SERVICE DIRECTIVE BULLETIN NO. 0099

1. SUBJECT: Non-Conforming Tie Rod Assemblies, P/N 28-16498-9 & 28-16498-101
2. MODEL: F-28F, 280F, and 280FX

Figure 1. Tie Rods, P/N 28-16498-9 & 28-16498-101

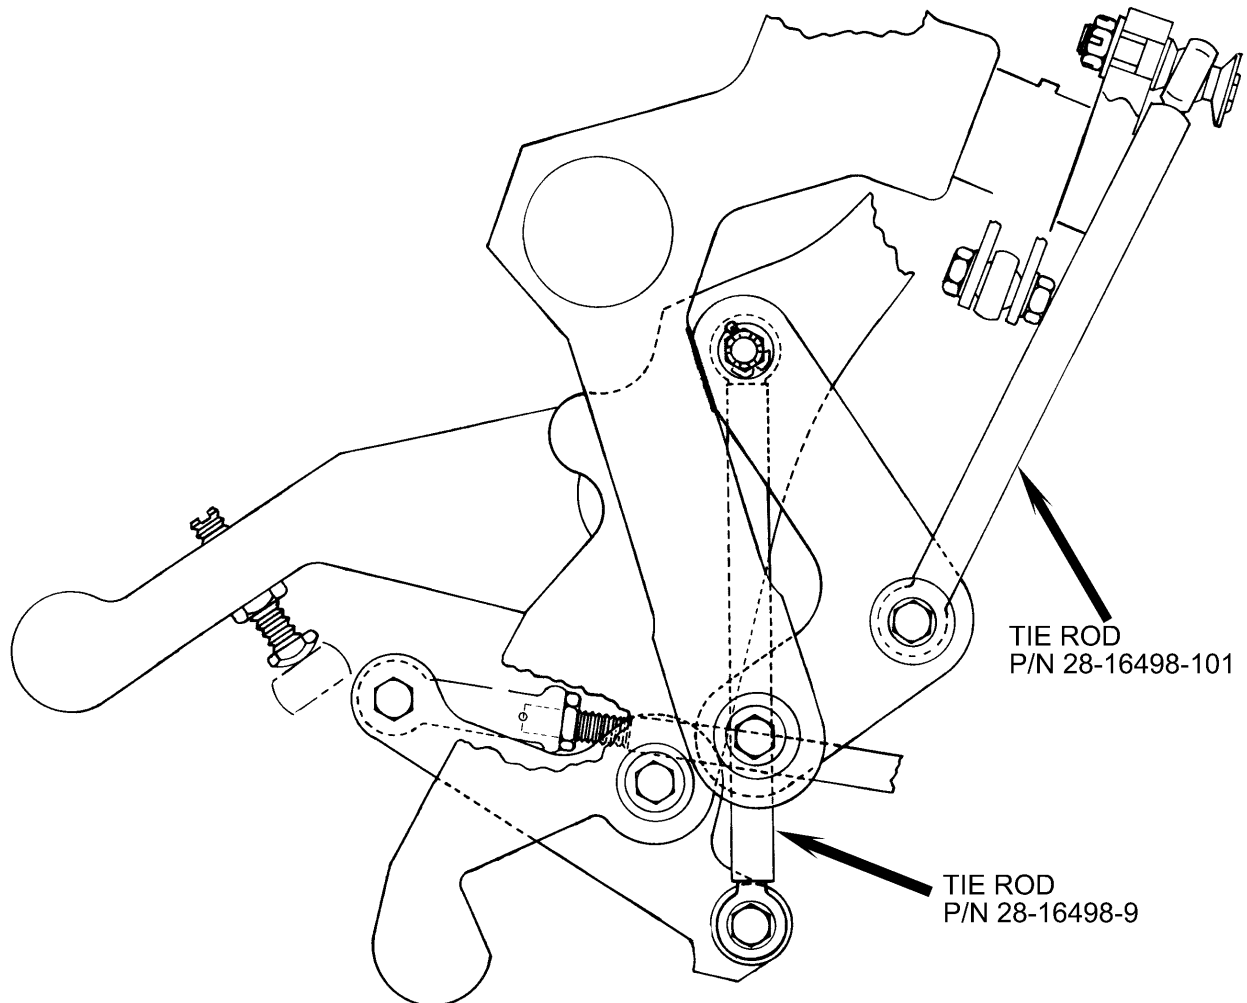
During the final inspection of newly manufactured tie rod assemblies, P/N 28-16498-9 and 28-16498-101, it was determined that the tie rod assemblies did not conform to the FAA approved engineering drawings. Review of the previous work orders of the tie rod assemblies showed the possibility of previously manufactured tie rod assemblies also not conforming to the approved drawings.

- B. Remove the tie rod, P/N 28-16498-9 and /or 28-16498-101, from the throttle correlator assembly (Refer to Figure 1).
- C. Determine if the tie rods conform to the approved drawings using the following procedures:

- 1. Using a gram scale, weigh the tie rod, P/N 28-16498-9.
 - a. If the tie rod weighs approximately 30.5 grams, the tie rod does not conform to the approved drawings and must be removed from service and/or parts inventory.

- b. If the tie rod weighs approximately 36.5 grams, the tie rod conforms to the approved drawing and may be returned to service and/or parts inventory.

- 2. Using a gram scale, weigh the tie rod, P/N 28-16498-101.
 - a. If the tie rod weighs approximately 31.0 grams, the tie rod does not conform to the approved drawings and must be removed from service and/or parts inventory.

- b. If the tie rod weighs approximately 37.0 grams, the tie rod conforms to the approved drawing and may be returned to service and/or parts inventory.

- D. After determining the conformity status of the tie rods, either reinstall the conforming tie rods and return the aircraft to service, or replace the non-conforming tie rods with conforming tie rods and return the aircraft to service.
